Amendments to the Drawings:

REMARKS

FIG. 1 (PRIOR ART)

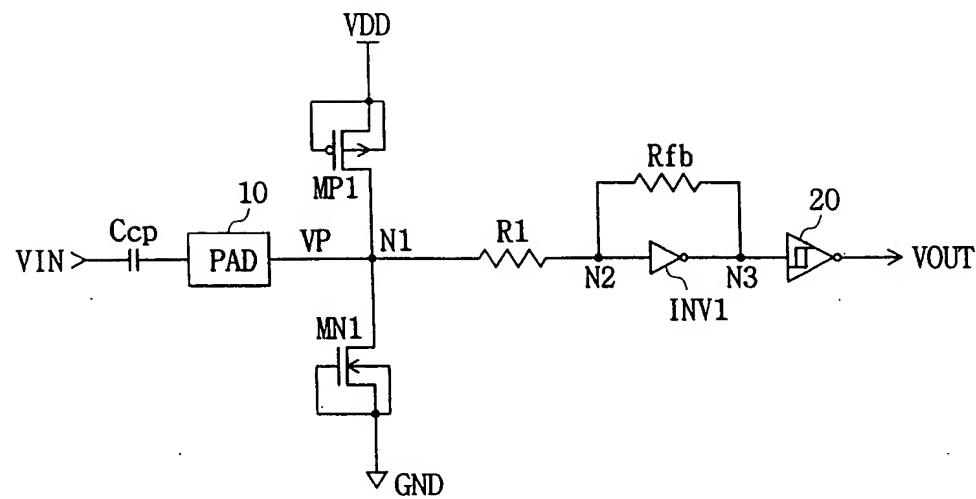
The attached sheets of drawings include changes to FIGs. 1-3. These sheets, which include FIGs. 1-4, replace the original sheets. FIGs. 1-3 have been changed to include the legend "Prior Art".

The drawings are objected to for reasons indicated in the Office Action. The drawings are amended herein to add the legend "Prior Art" to Figures 1-3. It is believed that the objection to the drawings is overcome, and reconsideration thereof is requested.
